Business/Project Name: Hip Sing Association Building

Record #: DONH-COA-01323

Per your request, this is a consolidated Response to the Department's **Correction Notice** uploaded in response to our application for Certificate of Approval of the painting of my clients building located at 420 8<sup>th</sup> Avenue South, Seattle, WA. As our previous responses, the Correction Notice raised a concern "about the existing paint color's non-compliance with Seattle Municipal Code Section 23.66.030." We filed a Response and two Supplemental Responses, and we have made several suggestions regarding remediation of the building to address compliance with the Code and with the existing and surrounding neighborhood color scheme. The last response from the City was to combine the responses into a single Response, eliminating the various "options" provided, and basically provide the City with our combined Response to that all the options are consolidated into one merged document for easier review and finalization.

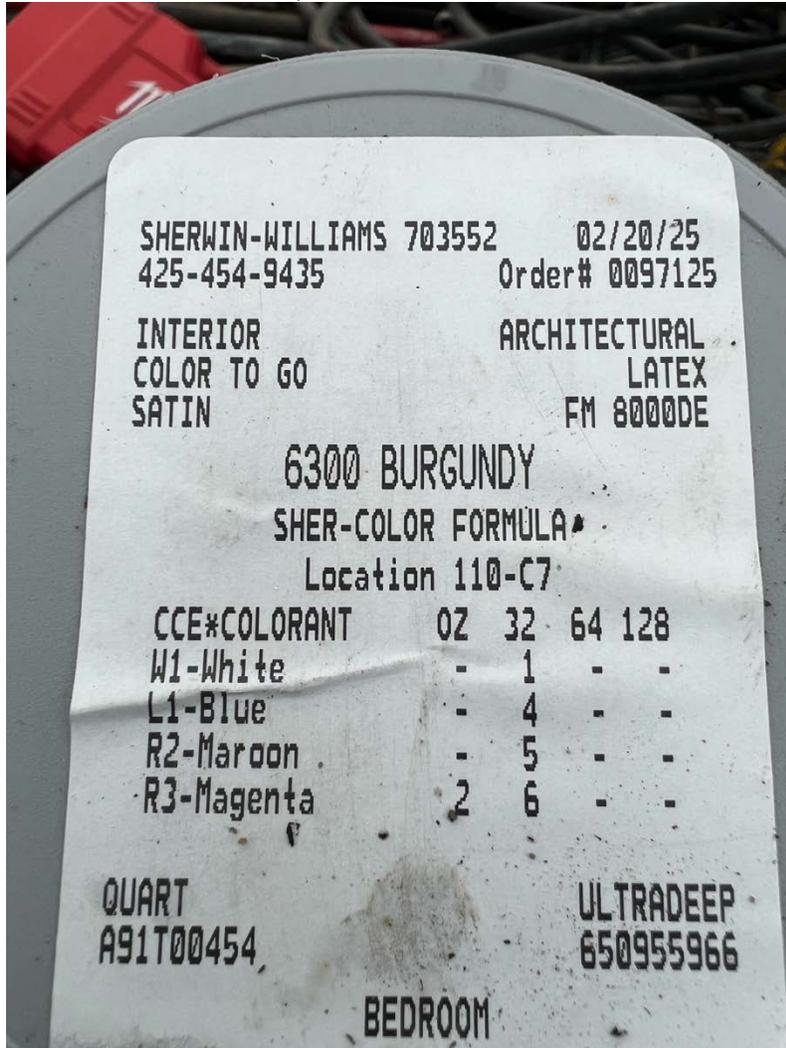
Window trim. New color on the right, SW #6300 Burdundy; window on the left is original trim. Window on the right will be painted and all windows with masonry trim and features will be SW #7641.

The sills and decorative features above the windows will be the accent color of SW #7641 Colonnade Gray.

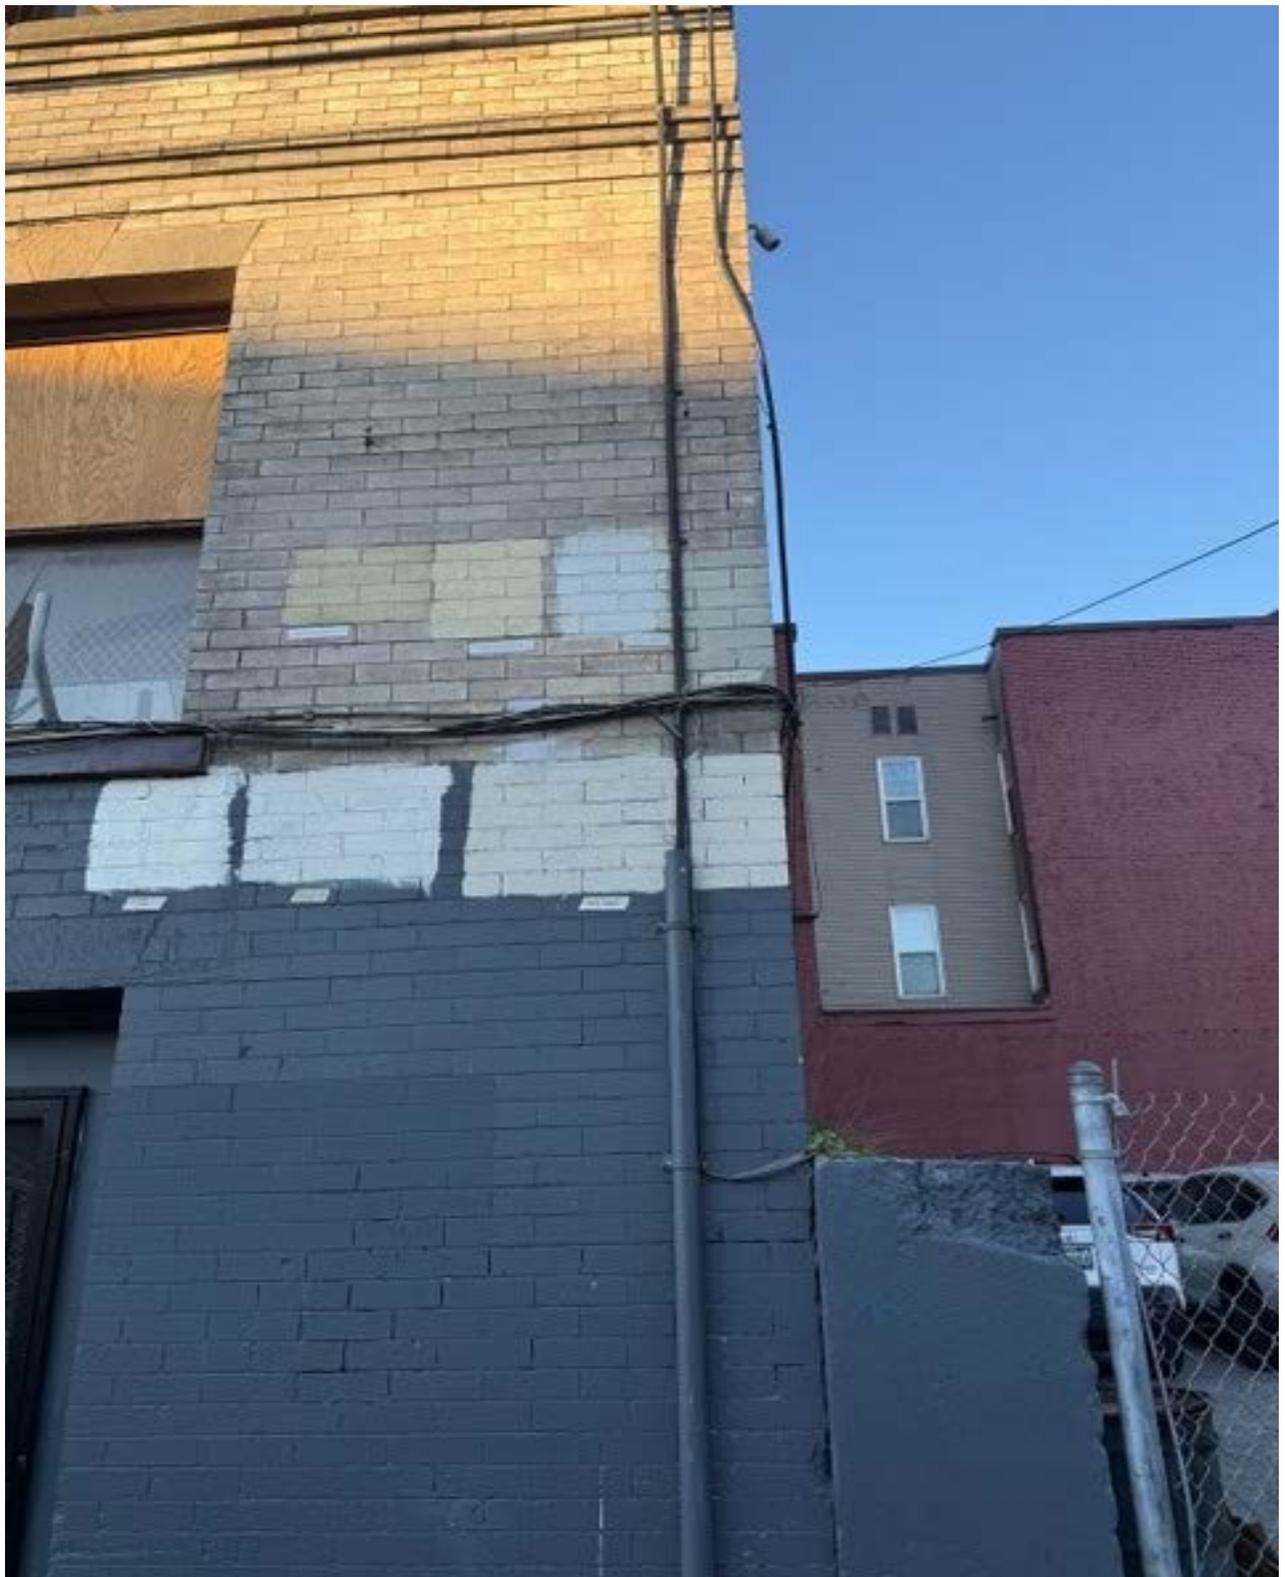
Next photo: Showing the various samples used to determine the best match for the original brick color on the South façade. Note that Skyline is the top right sample. (Please note that in a previous submission, the painter said the sample was “Skyline 1075” but the sample is actually “Skyline 1015” when we obtained the paint sample and double checked with Sherwin Willims. It was just a typo)
